[Docket No. 92-CE-63-AD; Amendment 39-9251; AD 95-12-01]

Airworthiness Directives; Piper Aircraft Corporation PA-25 Series Airplanes

ACTION: Final rule.

Appendix to AD 95-12-01—Procedures and Requirements for Wing Forward Spar Attachment Assembly; Inspection of Piper PA-25 Series Airplanes

FIGURE 1

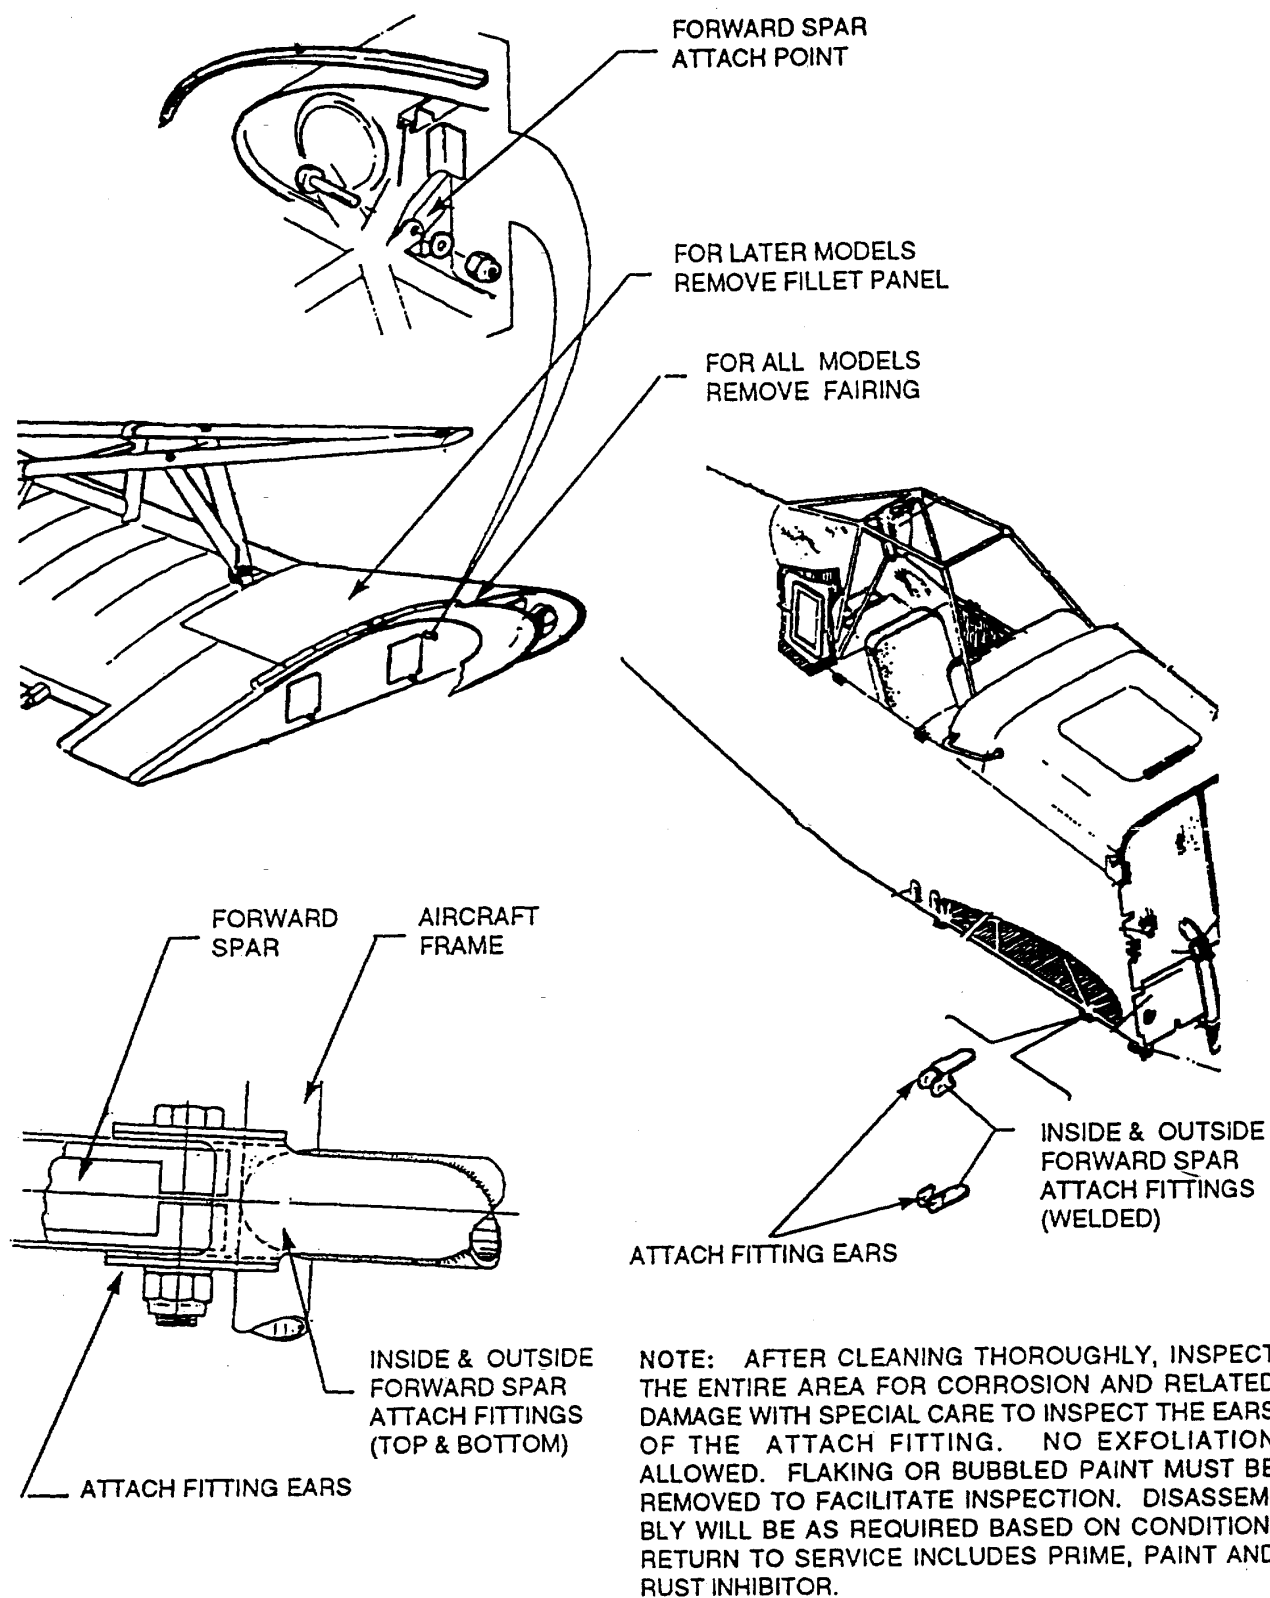
(a) Gain access to the left and right wing forward spar fuselage attach fittings by removing the screws retaining the wing fairing. Dismantle the wing fillet by removing the screws on the aft edge top and bottom and removing the wing fairing (see FIGURE 1 of the Appendix to this AD).

Figure 2

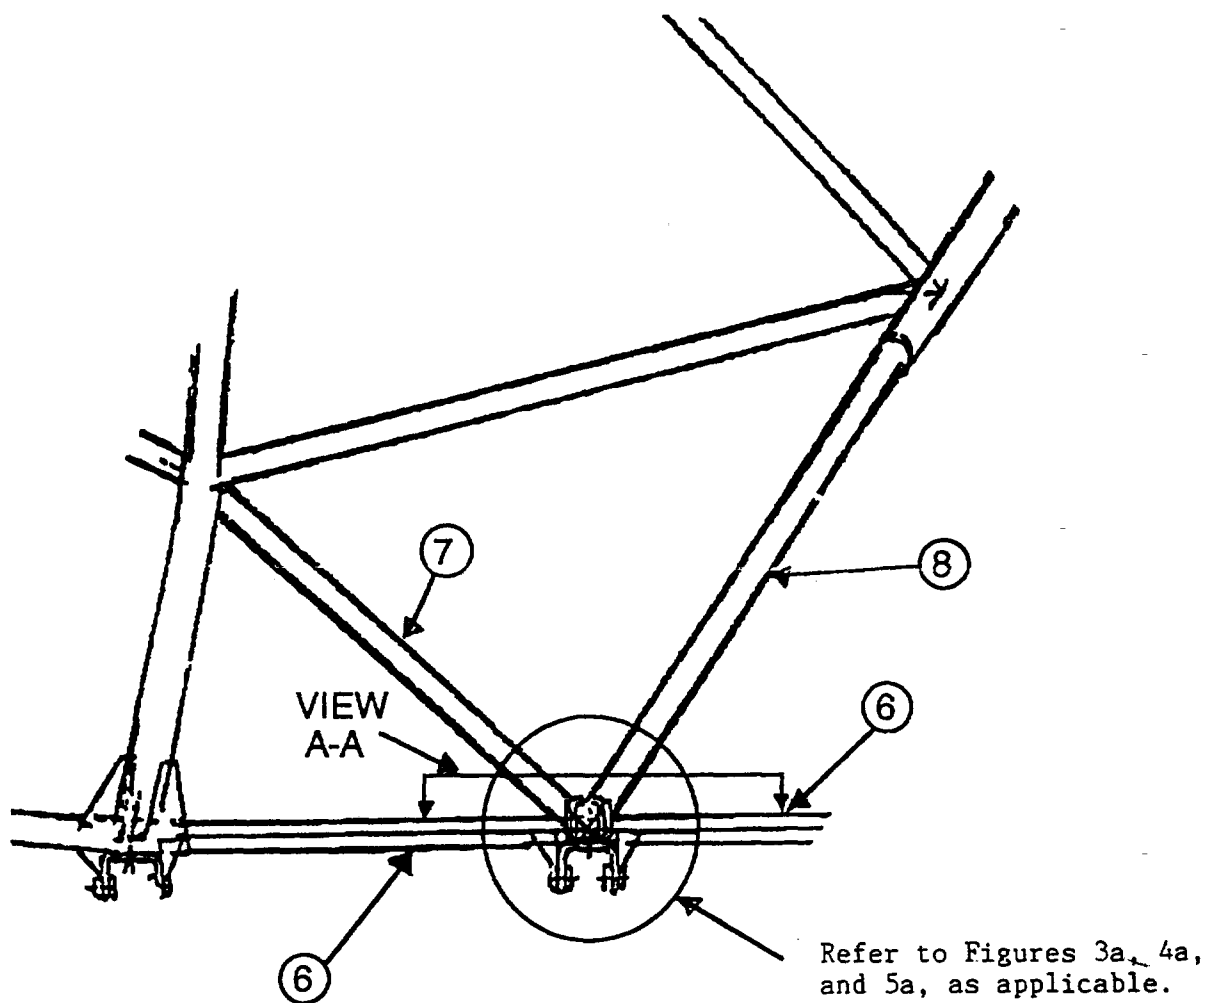
b. Cut the tubular members as referenced and specified in Figure 2 and either Figures 3a and 3b; Figures 4a and 4b; or Figures 5a and 5b, as applicable.

2. Cut the tubular members as referenced and specified in Figure 2 and either Figures 3a and 3b; Figures 4a and 4b; or Figures 5a and 5b, as applicable.

Figure 3a

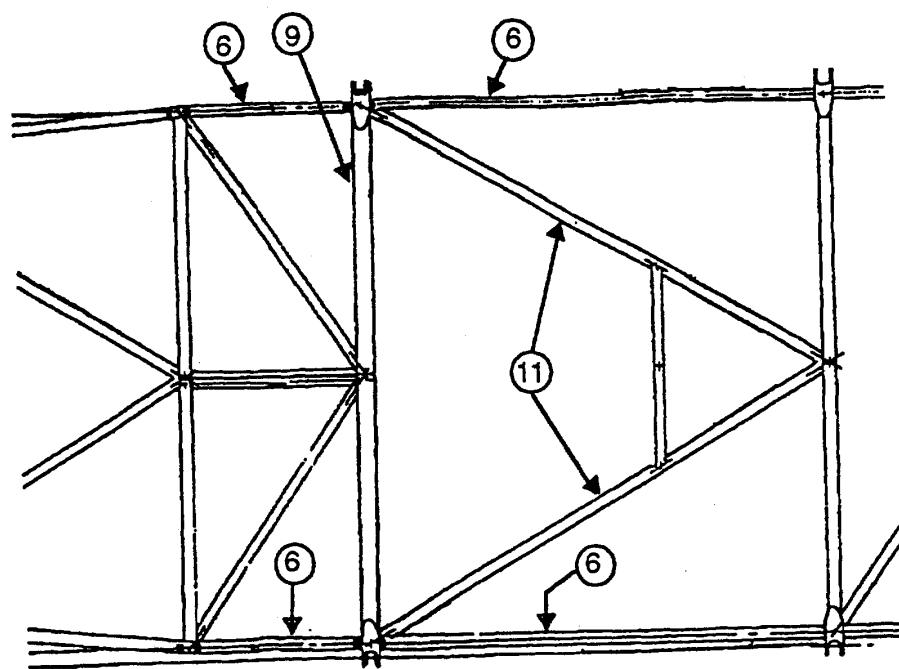
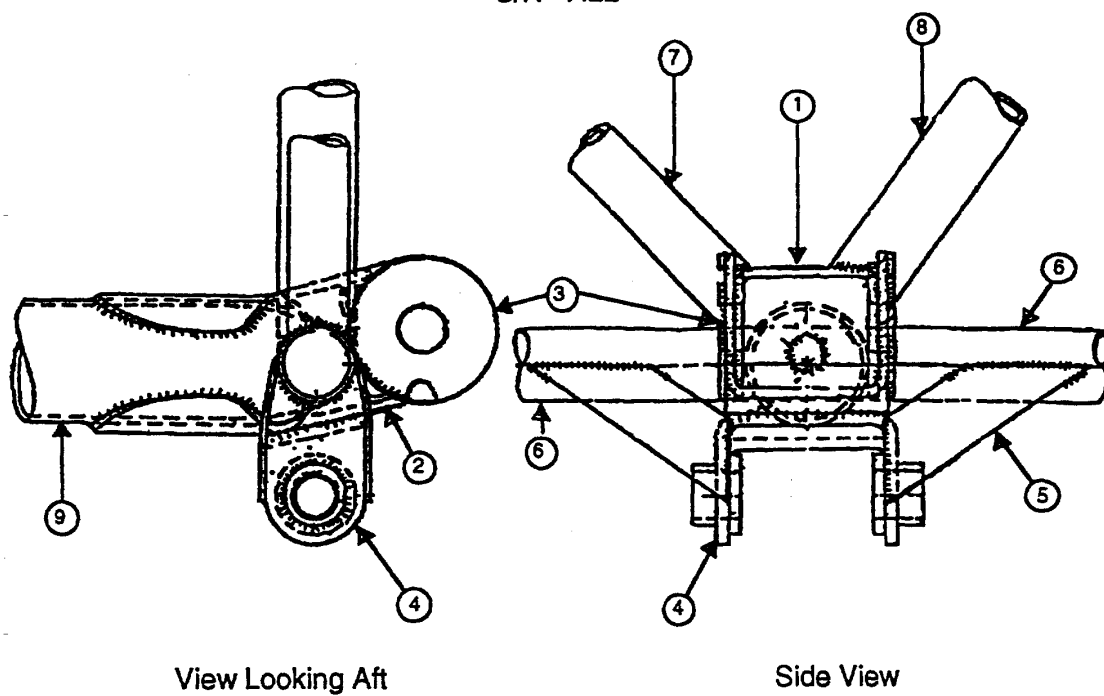
1. Add couplant to the outside inspection surface (Refer to Figures 3a, 4a and 5a, as applicable). Add the appropriate gain to obtain the backwall echo from the inspection surface. If the gain setting is adjusted, re-check the thickness values on the steel shims. To assure proper coupling to the test sample, twist the probe clockwise and counter-clockwise (with a 45-degree twist) and maintain contact with the test surface. During the articulation of the probe, observe the A-trace on the screen and stop the probe twist at the point of adequate back surface signal amplitude to trigger the thickness gate

2. Add couplant to the inside inspection surface (Refer to figures 3a, 4a and 5a, as applicable). Add the appropriate gain to obtain the backwall echo from the inspection surface. To assure proper coupling to the test sample, twist the probe (clockwise and counter-clockwise with a 45-degree twist). During the articulation of the probe, observe the A-trace on the screen and stop the probe twist at the point of adequate back surface signal amplitude to trigger the thickness gate on the first half-cycle. Measure and record the thickness. Repeat the above process at eight equally-spaced locations around the surface.
